UTILITY SERIAL NUMBER	PATENT DATE <b>JAN 27 1998</b>	PATENT NUMBER
SERIAL NUMBER 08/433,623	FILING DATE 05/03/95	CLASS 156
	SUBCLASS 643,1	GROUP ART UNIT
		EXAMINER A. HIGGINS

TITLE PROCESS OPTIMIZATION IN GAS PHASE DRY ETCHING

Applicant submits new figures 1-12, consisting of eight sheets of formal drawings. Newly submitted figures correct some inadvertent errors in the originally submitted formal drawings. Amendments to the originally submitted informal figures have been highlighted in red ink.

FIG. 1

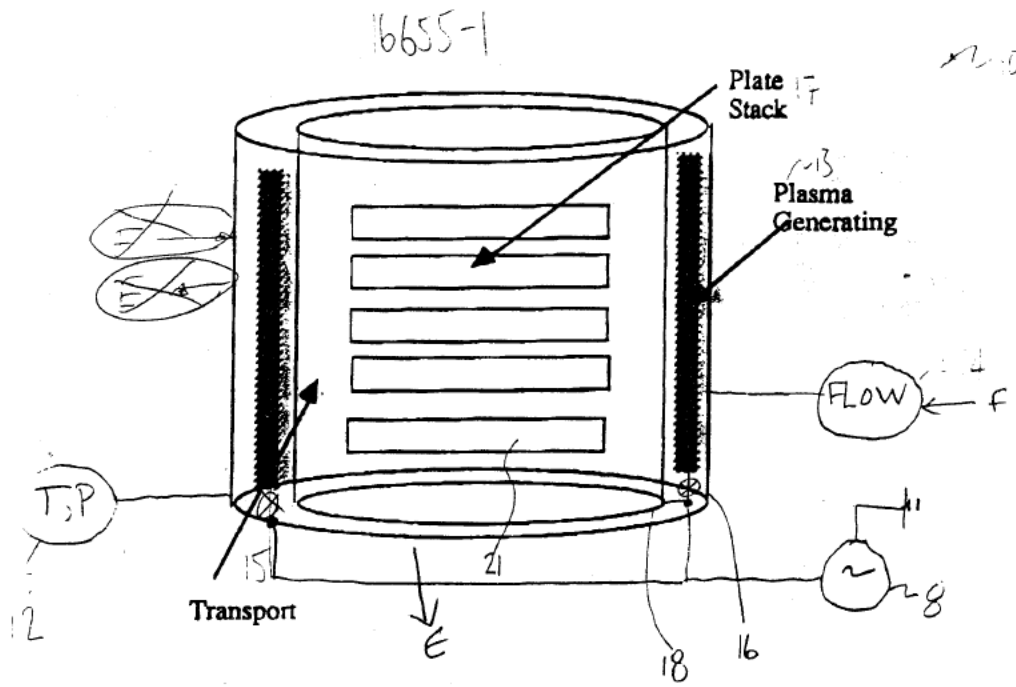
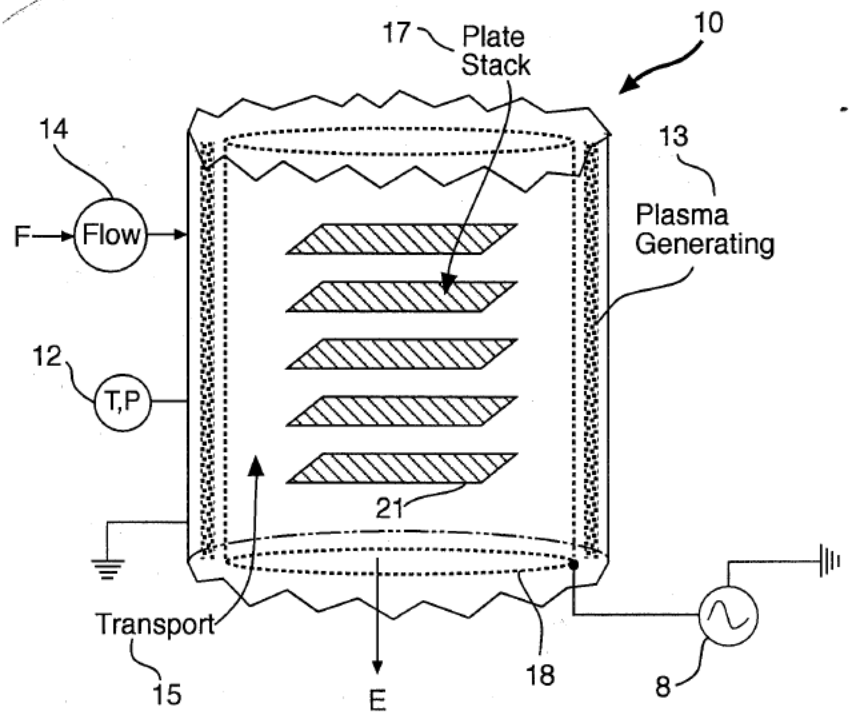
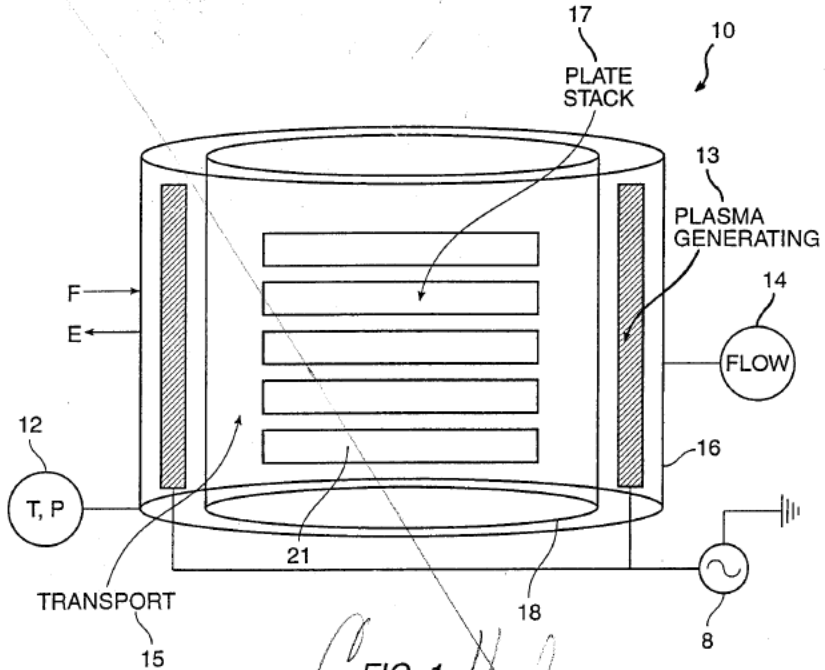
In Fig. 1, chemical flow source 14 was detached from the chemical feed  $F$ . In the new formal drawings chemical feed  $F$  is shown passing through the chemical flow source 14. Also, the ground connections have been amended to more clearly show the complete circuit for the rf discharge 8. Furthermore, the arrow indicating the exhaust  $E$  is moved to the chamber bottom.

With respect to Fig. 1, in the new formal drawings, chemical feed  $F$  is correctly shown passing through the chemical flow source 14. See, e.g., Specification, page 4, lines 15-22. Also, the ground connections now more clearly show the complete circuit for the rf discharge 8. Furthermore, the arrow indicating the exhaust  $E$  is moved to the chamber bottom for clarity because no opening is shown on the chamber side.

Fig. 3

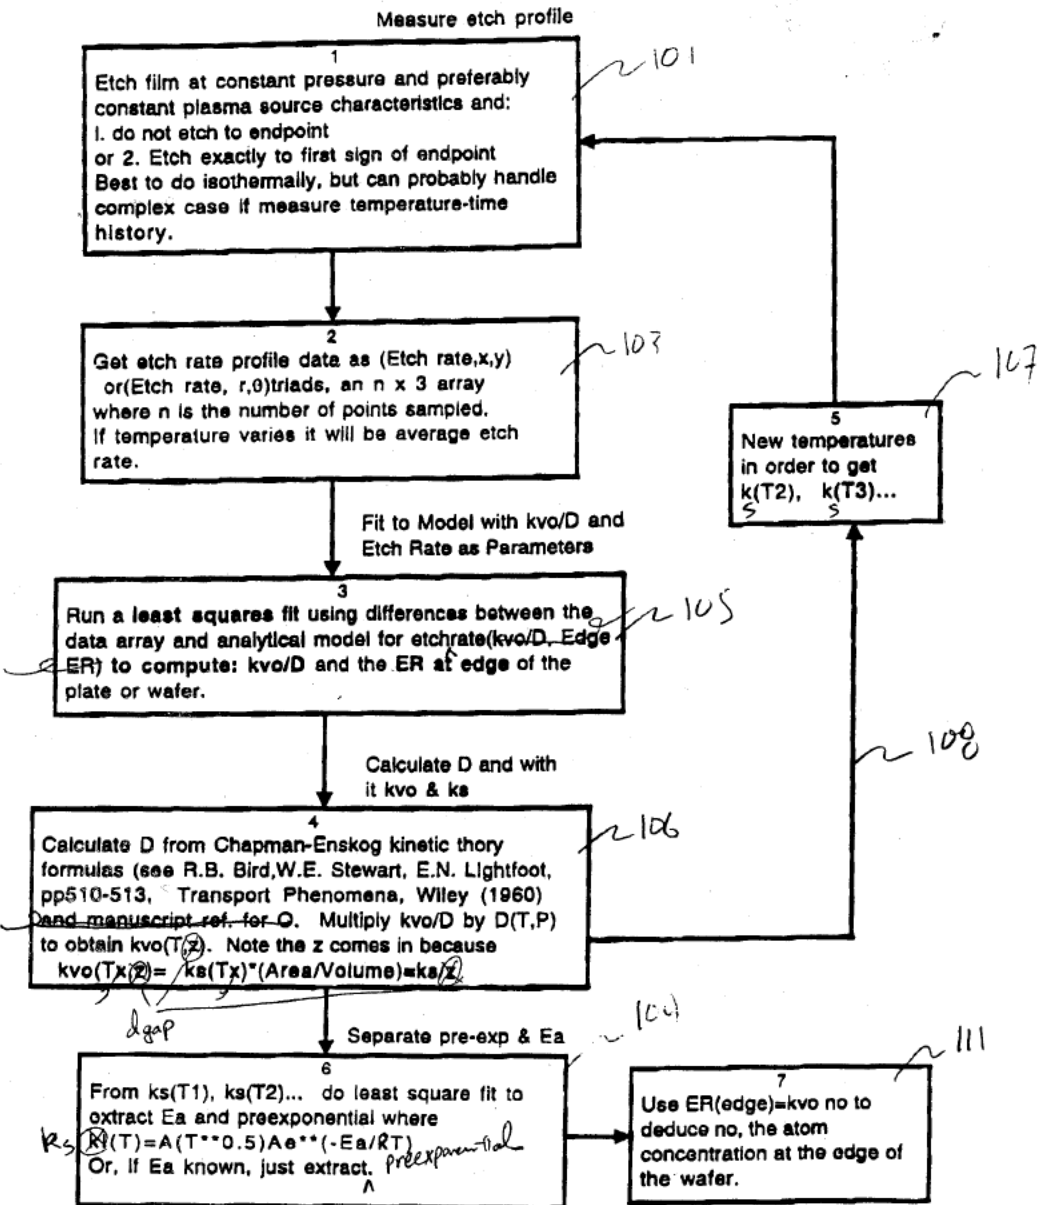
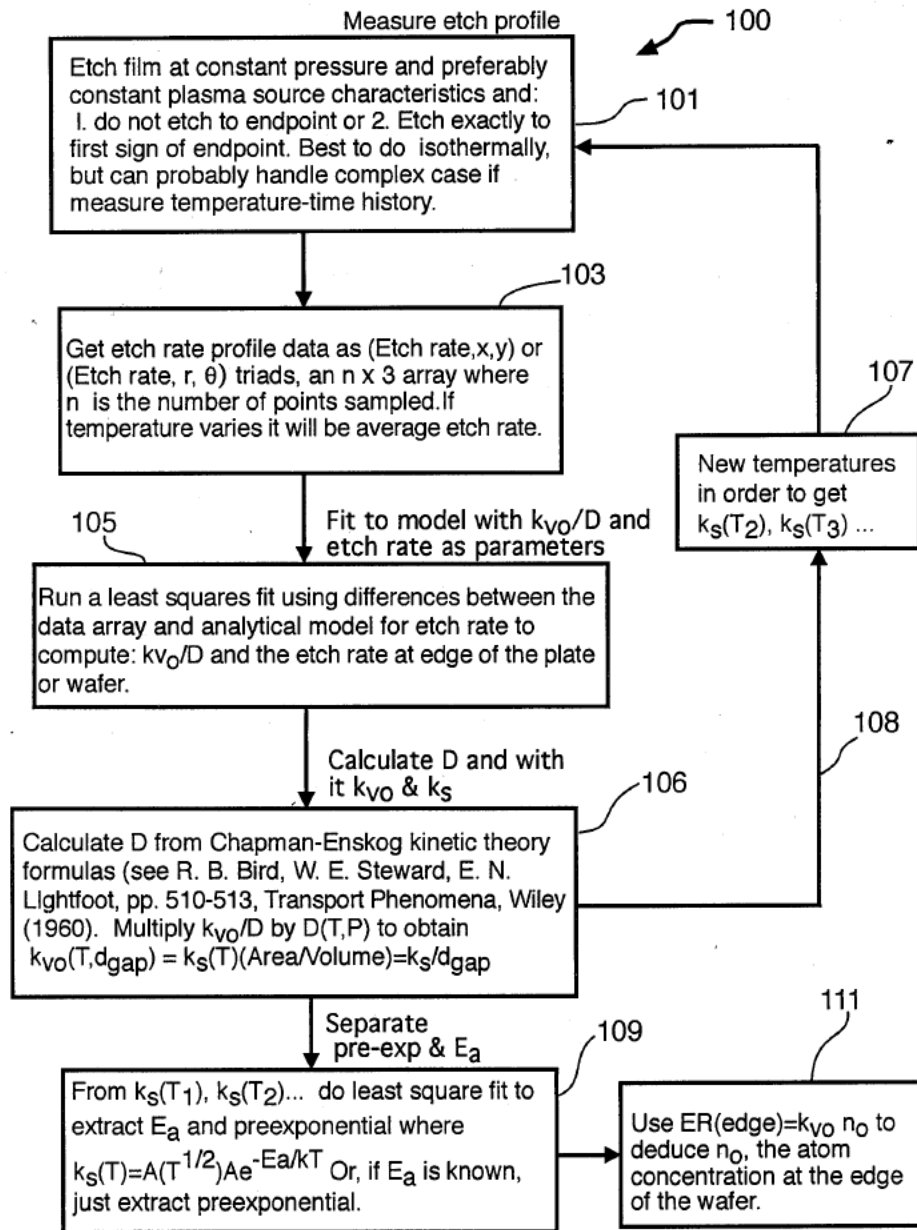
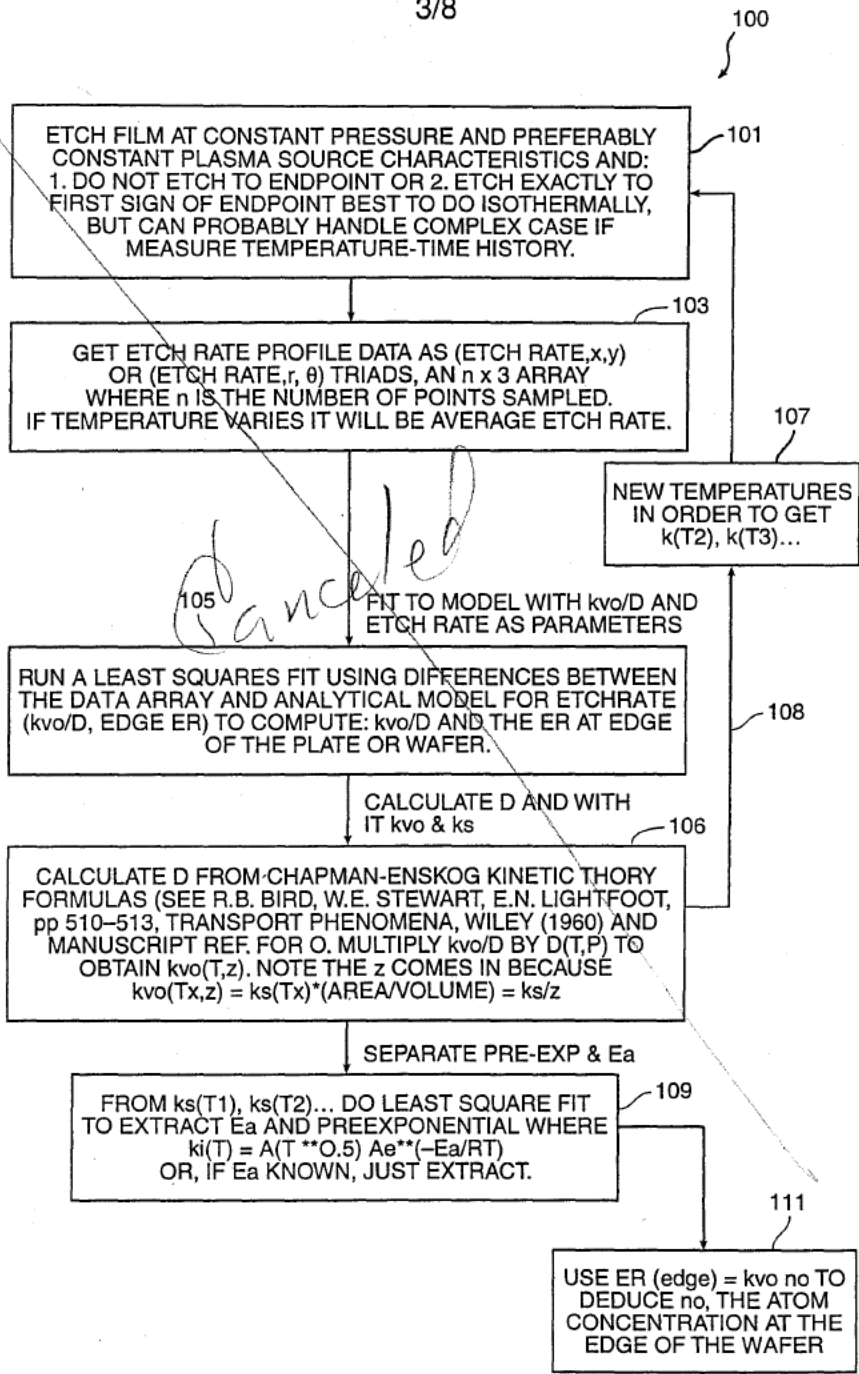
In Fig. 3, as highlighted in red ink, some editorial changes are made in boxes 105, 106, 107, and 109. For example, in box 109  $k_i(T)$  has been replaced with  $k_s(T)$ . In box 106, "z" has been replaced with " $d_{gap}$ ". Similarly in box 107, "k" has been replaced with " $k_s$ ". In box 109,  $k_i$  has been replaced with  $k_s$  and "preexponential" has been added at the end.

With respect to Fig. 3, some editorial changes are made in boxes 105, 106, 107, and 109 for consistency with the Specification or to correct some typographical errors. For example, in box 109  $k_f(T)$  is replaced with  $k_s(T)$  to maintain consistency with the text. See, e.g., Specification, page 11, the equation after line 15. In box 106, "z" is replaced with " $d_{gap}$ " for consistency with the Specification, for example, at page 11, the equation after line 5. Similarly in box 107, "k" is replaced with " $k_s$ " for consistency with the Specification.

FIG. 4

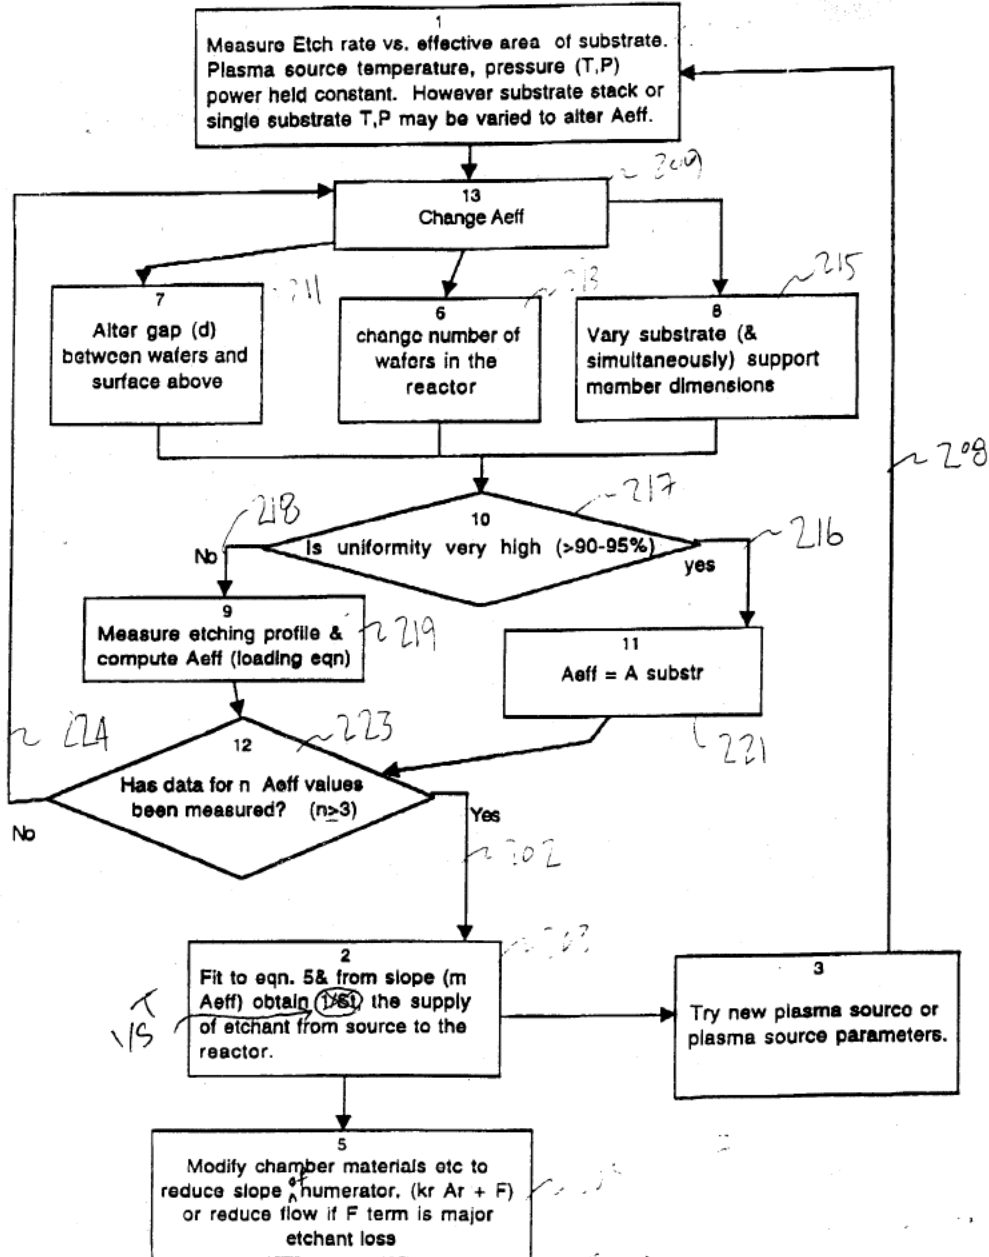
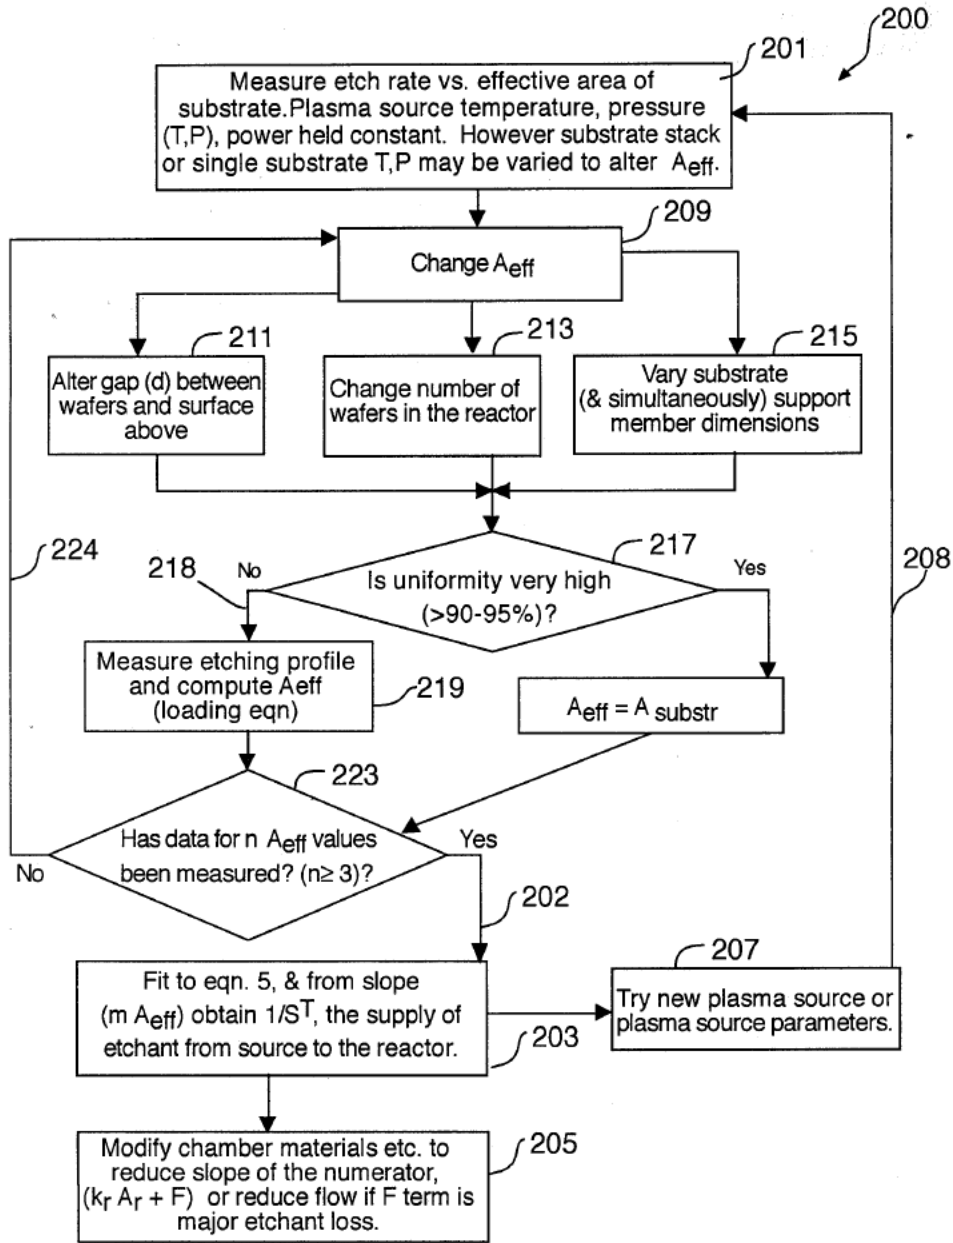
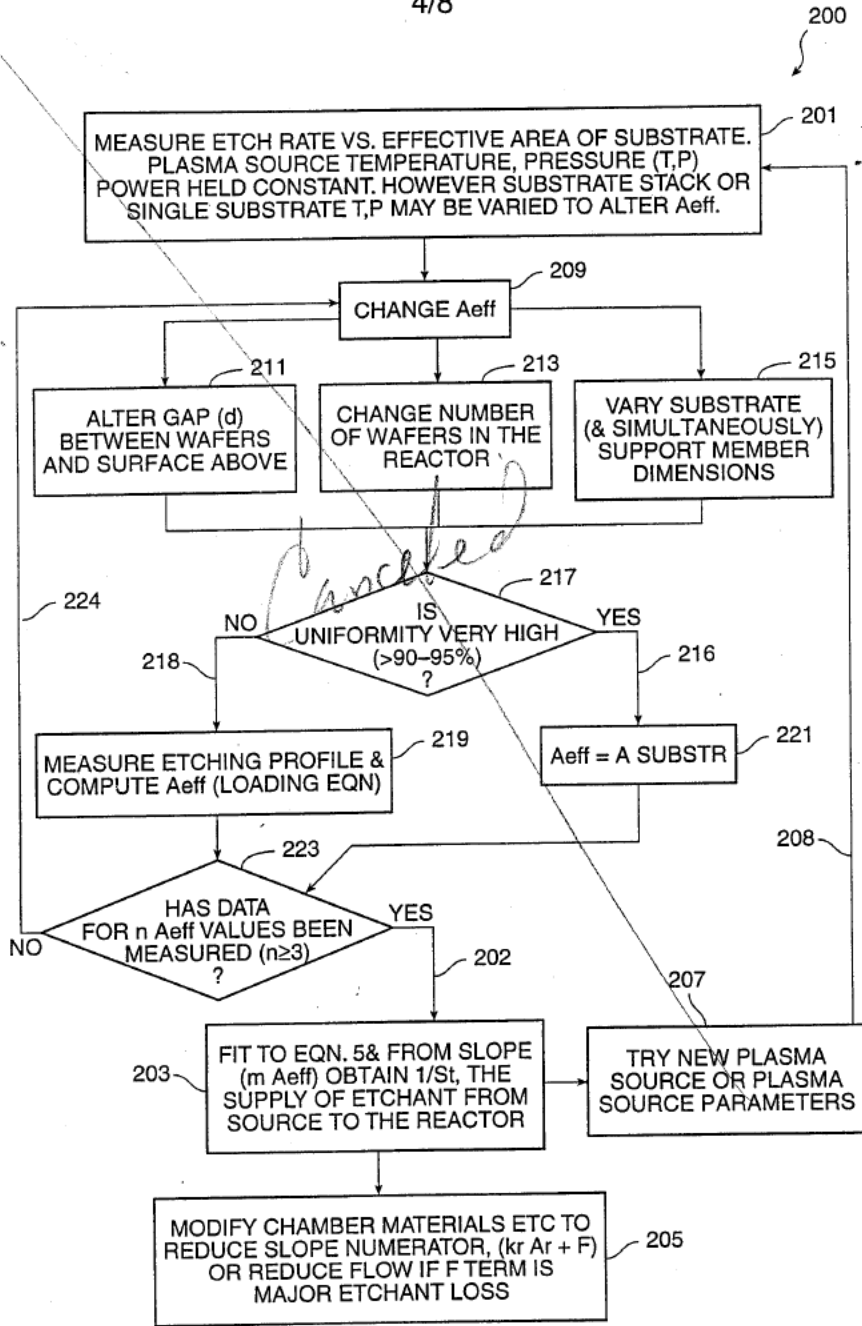
In Fig. 4, some editorial changes are made in boxes 203 and 205. In box 203, "St" is replaced by " $S^m$ ". In box 205, "of" is added after slope.

FIG. 7

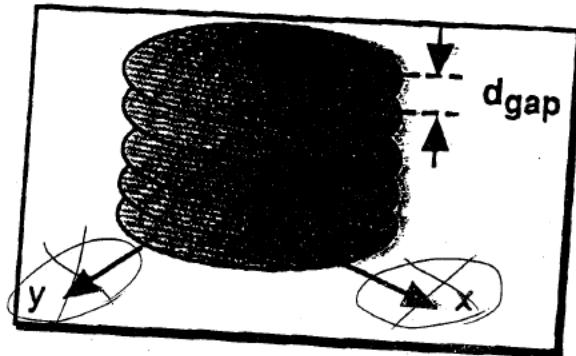
In Fig. 7, the two Cartesian axes at the bottom of the informal drawing are deleted.

With respect to Fig. 7, the two Cartesian axes at the bottom of the informal drawing are deleted because they are not referenced or used in the radial coordinate system of this figure.
